SUBJECT: DIABLO CANYON POWER PLANT, UNIT NOS. 1 AND 2 - STAFF
ASSESSMENT OF INFORMATION PROVIDED UNDER TITLE 10 OF THE
CODE OF FEDERAL REGULATIONS PART 50, SECTION 50.54(f), SEISMIC
HAZARD REEVALUATIONS FOR RECOMMENDATION 2.1 OF THE
NEAR-TERM TASK FORCE REVIEW OF INSIGHTS FROM THE FUKUSHIMA
DAI-ICHI ACCIDENT (CAC NOS. MF5275 AND MF5276)

STAFF ASSESSMENT BY THE OFFICE OF NUCLEAR REACTOR REGULATION

RELATED TO SEISMIC HAZARD AND SCREENING REPORT

DIABLO CANYON POWER PLANT UNIT NOS. 1 AND 2

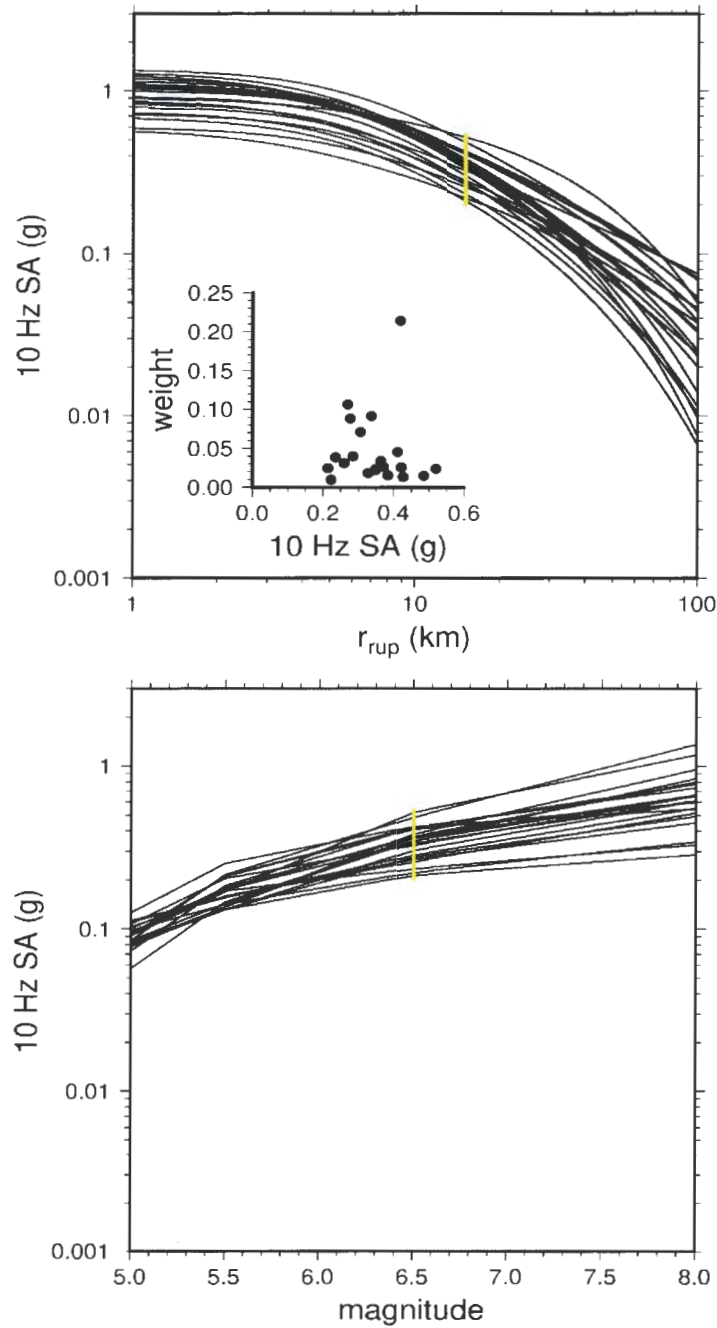
To evaluate the distribution of median GMPEs produced by the TI Team for the local sources, the NRC staff examined the behavior of the models for multiple earthquake magnitude and source-to-site distance combinations. Figure 3.2-1(a-b) of this staff assessment shows the distribution of weighted medians produced by the set of GMPEs using the Sammon's map approach for the local sources. Specifically, Figure 3.2-1(a) shows the distribution of weighted median results from the 22 GMPEs developed for a spectral period of 0.1 s for a **M6.5** earthquake for source-to-site distances ranging from 1 km to 100 km. Similarly, Figure 3.2-1(b) shows the same GMPEs for a source-to-site distance of 15 km for earthquake magnitudes ranging from **M5** to **M9**. Shown in the inset to Figure 3.2-1(a) is the weighted distribution of median spectral accelerations for a **M6.5** earthquake at a source-to-site distance of 15 km. As shown by the inset to Figure 3.2-1(a), the 22 predicted weighted medians are centered at a reasonable value (0.4g) and cover a suitably wide range of spectral accelerations (0.2g to 0.6g). In addition, Figures 3.2-1(a) and (b) show that the 22 median GMPEs have alternative magnitude and distance scaling approaches, as demonstrated by the intersecting models.

Figure 3.3-1. Four local faults (black lines) and virtual faults (yellow lines) used in the NRC staff's confirmatory analyses.

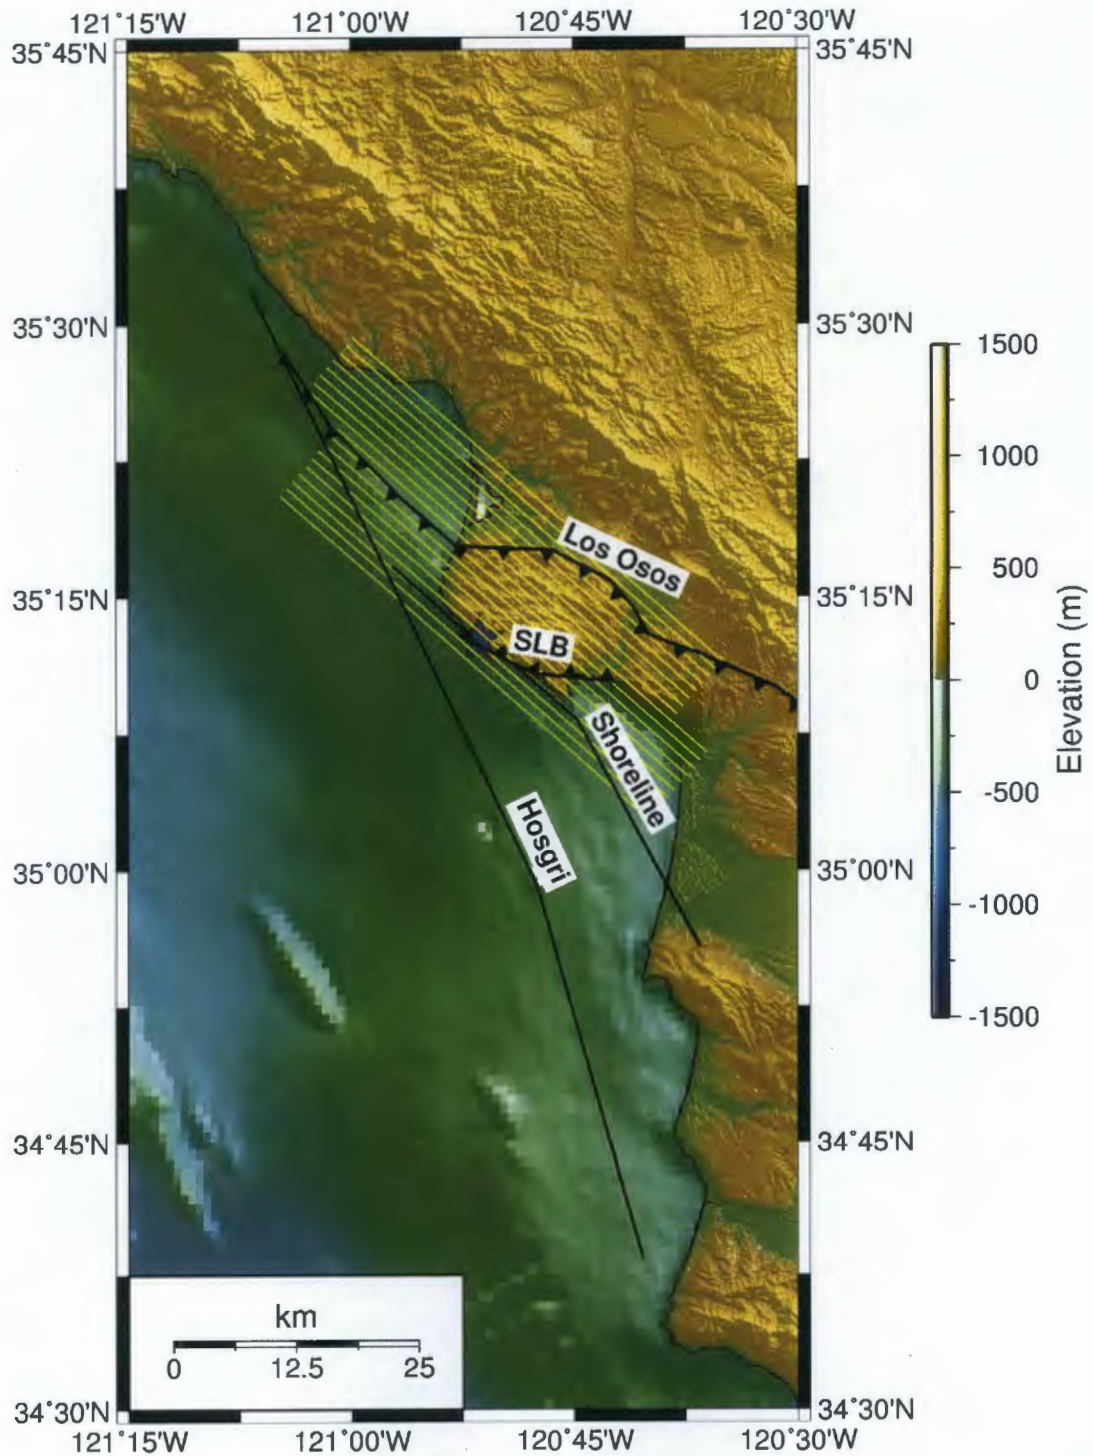
For the Local areal source zone, the TI Team modeled 18 subparallel, 50-km-long faults striking N50°W, with a spacing of 1 km (see Figure 3.3-1 of this staff assessment). The TI Team modeled the characteristics of these virtual faults by their fault geometry (i.e., location, strike, length, down-dip width, and dip), sense of slip, and M_{max} , including both aleatory and epistemic uncertainty. The TI team developed these characteristics from geologic, geophysical, and seismological data, such that the resulting virtual faults are consistent with its interpretations of the overall geologic structural and seismotectonic setting of the DCPD site. The sense of slip information was derived by the TI Team from the single-event and composite focal mechanisms from Hardebeck (2010, 2014), with additional data and analysis presented at the SSHAC workshops. The TI Team determined the rates of earthquakes in this areal source zone based on observed seismicity rates and considerations of geologic rates of deformation. Similar to the Regional and Vicinity source zones, the TI Team distributed the seismicity as 70 percent strike-slip and 30 percent reverse-slip earthquakes. The TI Team estimated M_{max} on the virtual faults based on the maximum dimensions of the virtual faults and applying the same magnitude-area scaling relationships used for the primary and connected fault sources.

The local fault sources selected by the NRC staff for its confirmatory evaluation are the Hosgri, Shoreline, Los Osos, and San Luis Bay faults (see Figure 3.3-1 of this staff assessment). For each of the fault sources, the staff primarily focused on either the Hosgri or the Outward Vergent Fault geometry model and modeled a range of earthquake ruptures on these primary faults using the characteristic earthquake distribution (Youngs and Coppersmith, 1985). Rather than

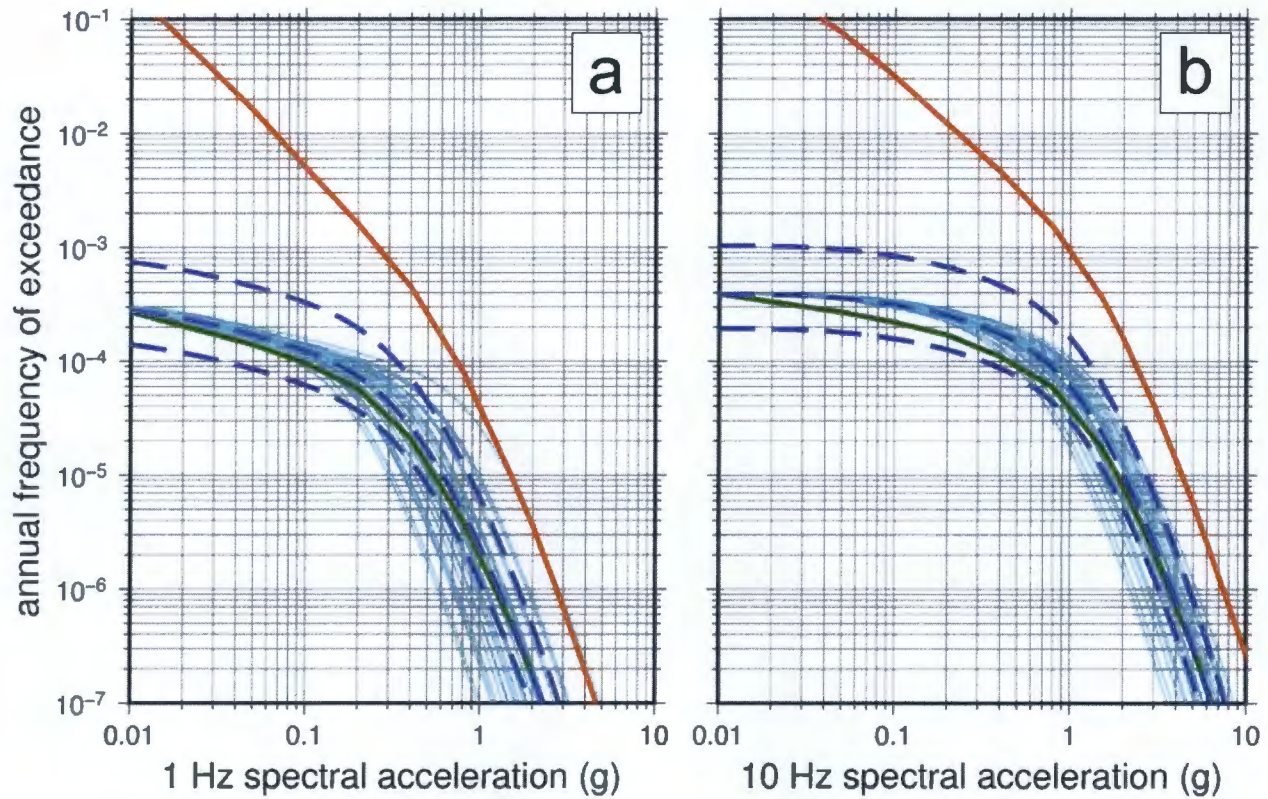
Figures 3.3-3(a-b) of this staff assessment show the NRC staff's 1 and 10 Hz hazard curves for the Shoreline fault assuming the OV-01 fault geometry model, a maximum magnitude of 6.7, a fault length of 51 km, a width of 12 km, and fault slip rates of 0.03, 0.06, and 0.16 mm/yr. As shown in Figures 3.3-3(a-b), the NRC staff's confirmatory results encompass the licensee's hazard results for both the 1 Hz and 10 Hz mean hazard curves. Similarly, for the Los Osos and San Luis Bay faults, the staff used the OV-07 and OV-05 Outward Vergent rupture models along with the 5th, 50th, and 95th percentile fault slip rates to develop 1 Hz and 10 Hz hazard curves. The staff's confirmatory results for these faults are similar to the licensee's results at the 10⁻⁴ and 10⁻⁵ annual frequencies of exceedance even though the SSC TI Team allocated only a portion of the total fault slip rates to these two rupture models. Additionally, the staff notes that these confirmatory calculations, similar to the licensee's calculations, show that the seismic hazard at the DCPD is controlled by the Hosgri fault.

Figure 3.4-5. Licensee's sensitivity analysis of the Uniform Hazard Spectra to the site term approach, from PG&E (2015d).

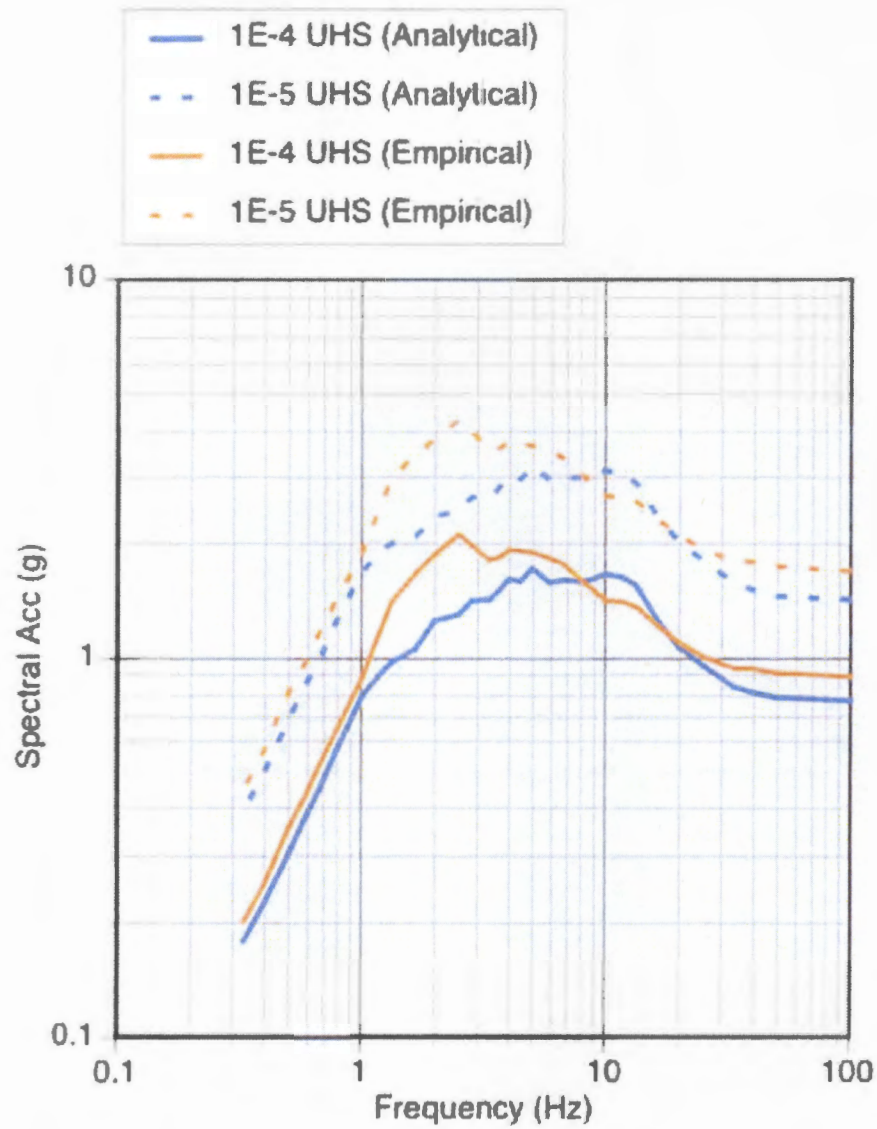
Figure 3.4-5 from the licensee's revised SHSR (PG&E, 2015d) shows the 10^{-4} and 10^{-5} annual exceedance frequency uniform hazard response spectra (UHS) from the empirical and analytical approaches. The main difference between the two UHS is the site resonance near 2 Hz that is captured by the empirical approach, but not by the analytical approach. The NRC staff notes that the licensee's decision to more heavily weight the empirical approach retains this 2 Hz amplification as part of the final GMRS for the DCPD.

Figure 3.5-1. Initial Ground Motion Response Spectrum (GMRS; black dashed line) and Double Design Earthquake (i.e., SSE; green dashed line) from SHSR for DCPD (PG&E, 2015a). Revised GMRS (red solid line) from PG&E (2015d).

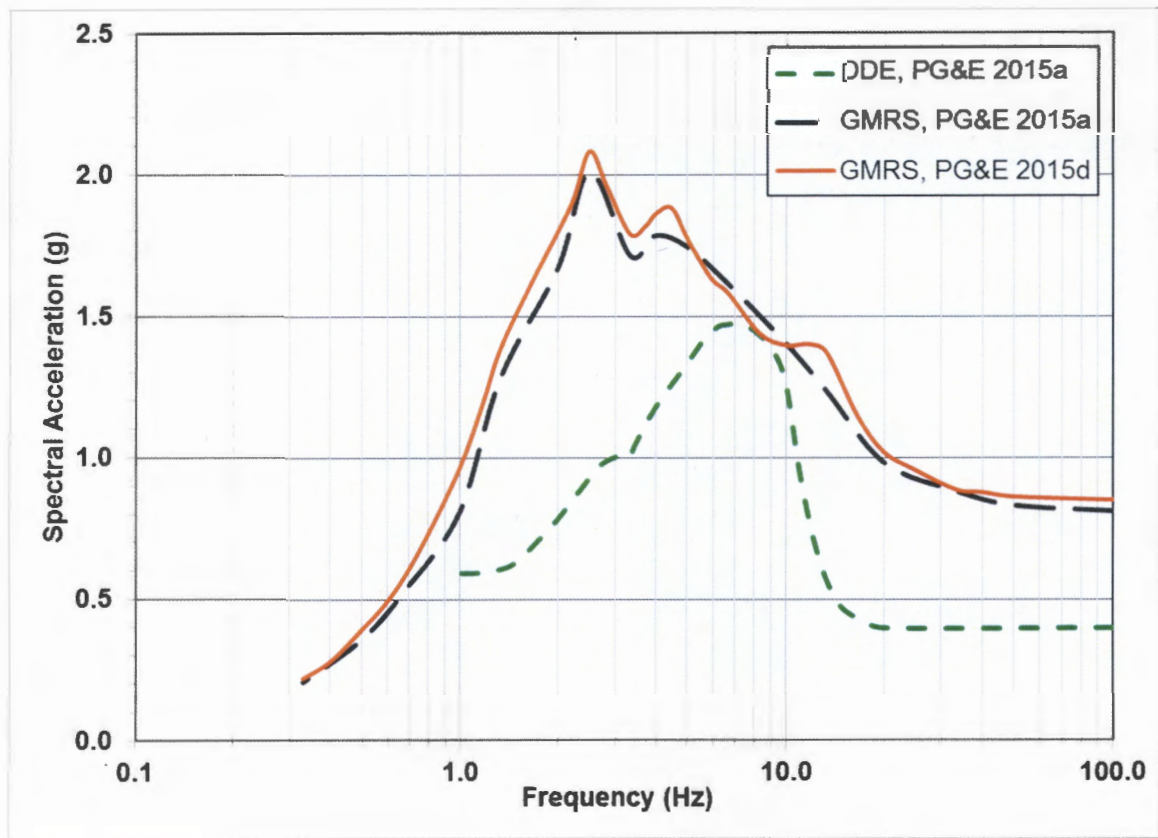
The GMRS is used to represent the free-field seismic hazard at the control point elevation. To calculate the GMRS, the licensee first used site-specific rock hazard curves from the PSHA (reviewed in Section 3.3 of this staff assessment) and the site term adjustment factors (reviewed in Section 3.4) to calculate control point hazard curves. The licensee then used these curves to develop 10^{-4} and 10^{-5} (mean annual frequency of exceedance) uniform hazard response spectra, and then computed the GMRS using the criteria in Regulatory Guide 1.208 (NRC, 2007). In response to RAIs, the licensee updated the GMRS initially submitted in PG&E (2015a) to incorporate additional information in the DCPD site response (PG&E, 2015d). The licensee's initial and updated horizontal GMRS for the DCPD site are shown in Figure 3.5-1 of this staff assessment.
